**ADC PARKS & GREENSPACE ARBORICULTURE**

**PLANNING APPLICATION:** P/58/15/OUT

**ADDRESS:** Land at Summer Lane Pagham PO21 4NG

**BRIEF DESCRIPTION:** Outline application with some matters reserved for the erection of 90 No. dwellings with associated access & open space. This is a Departure from the Development Plan.

Figure 2 Default specification for protective barrier

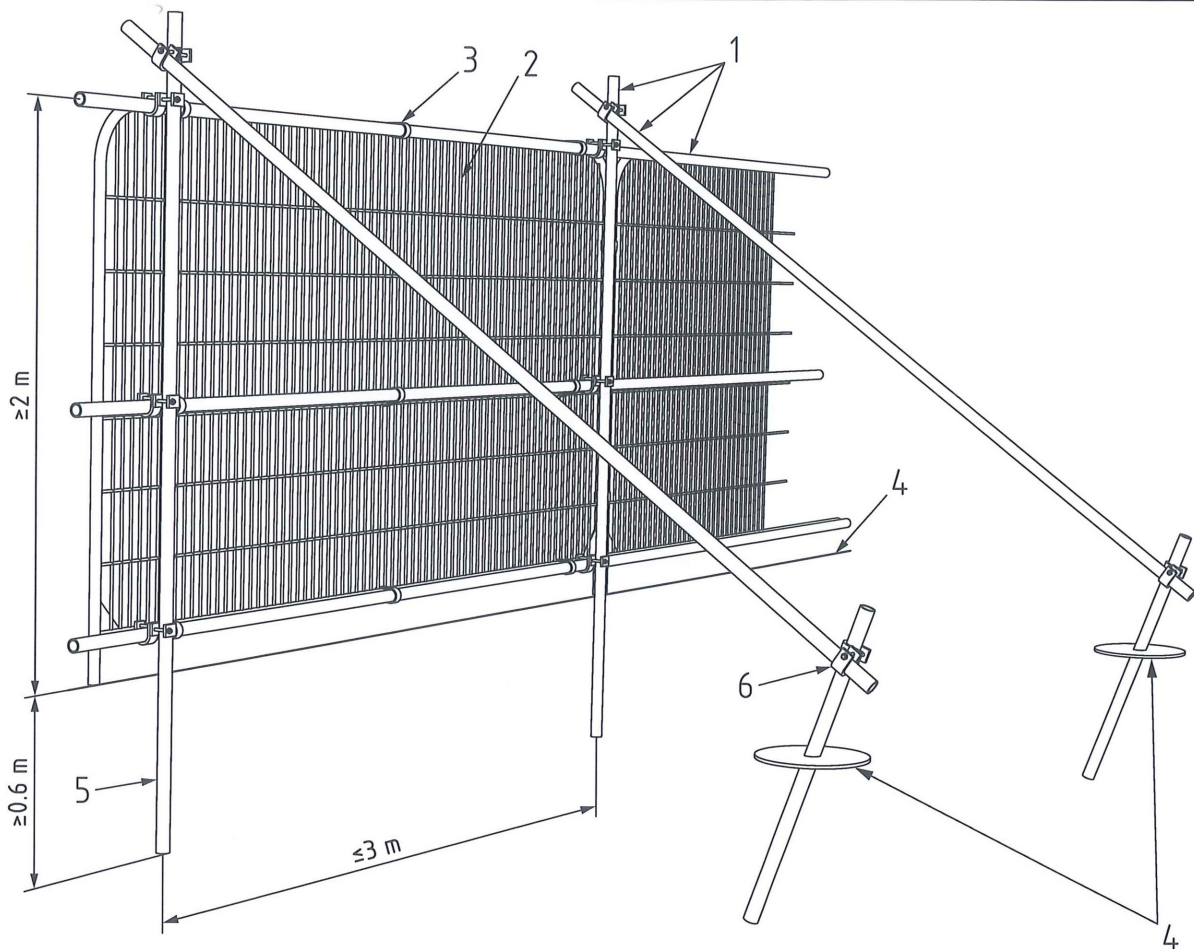
- Once the protective fencing has been erected, the Local planning authority arboricultural officer must be contacted to ensure the fencing is

correctly placed. This fencing must be erected and kept in place for the duration of the development works.
